ADDENDUM NO. 1

VILLAGE OF ARCANUM South Main Street Reconstruction November 15, 2013

Re: Village of Arcanum
South Main Street Reconstruction

SOUTH STREET

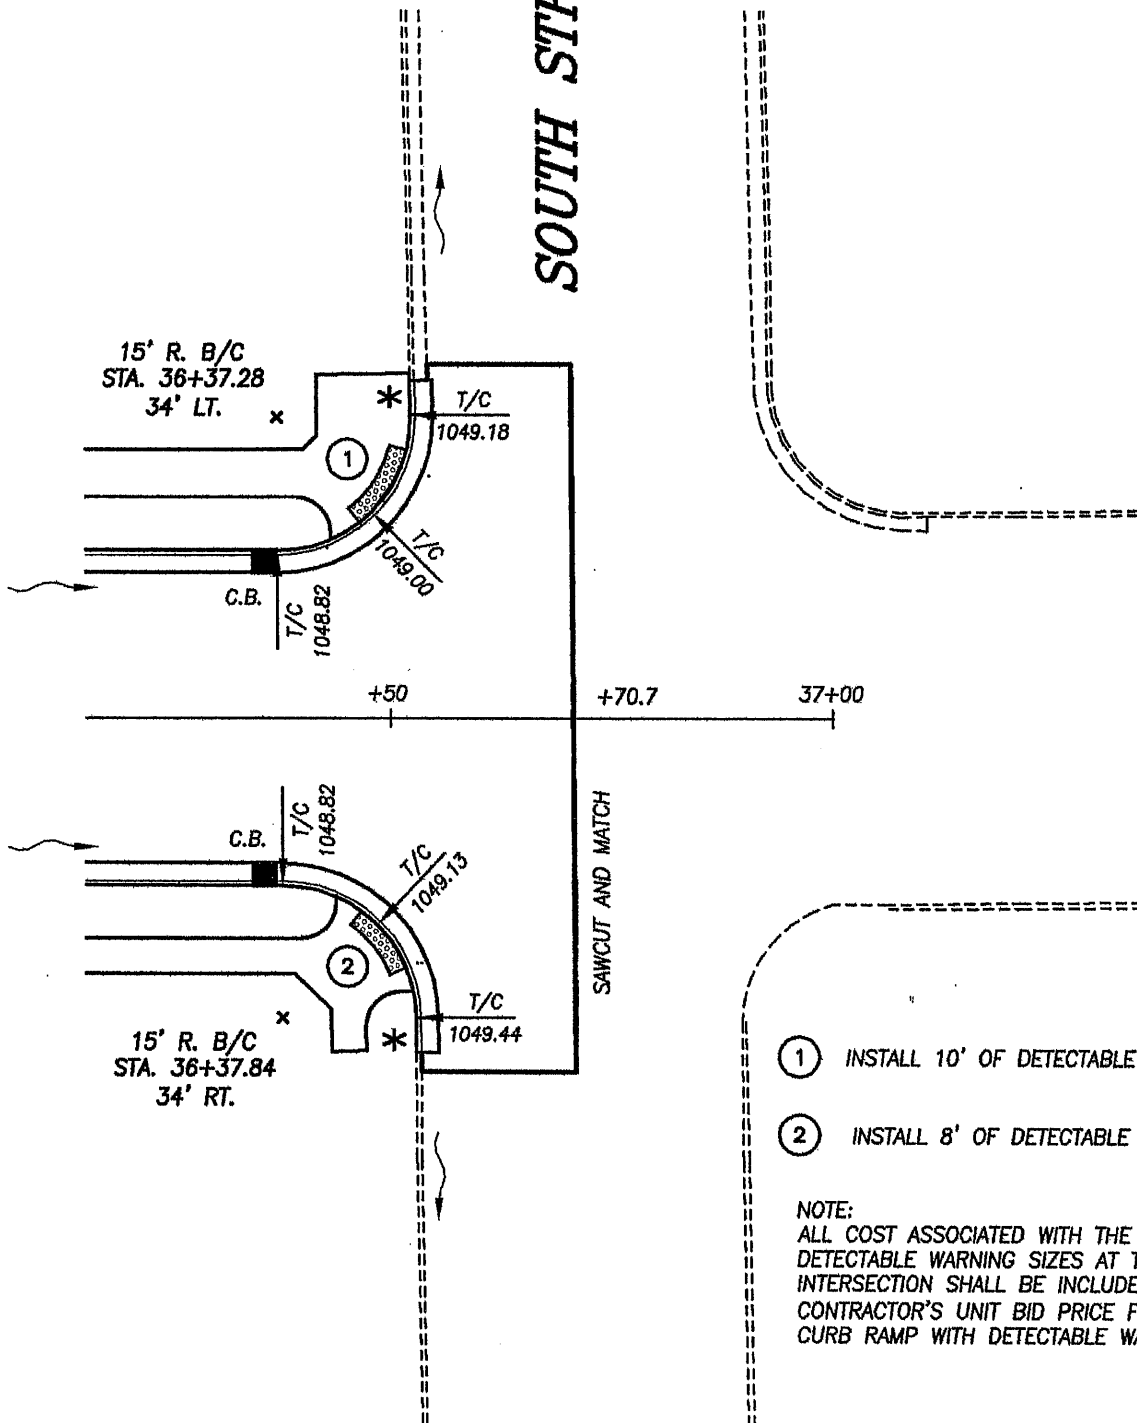
7. Sheet #16 of #24 – Plan & Profile Sheet

The detectable warnings located at the intersection of South Main Street and South Street shall be increased in size as shown on the Intersection Detail attached to this Addendum.

- ① INSTALL 10' OF DETECTABLE WARNINGS
- ② INSTALL 8' OF DETECTABLE WARNINGS

NOTE:
 ALL COST ASSOCIATED WITH THE INCREASED DETECTABLE WARNING SIZES AT THIS INTERSECTION SHALL BE INCLUDED IN THE CONTRACTOR'S UNIT BID PRICE FOR THE CURB RAMP WITH DETECTABLE WARNINGS.
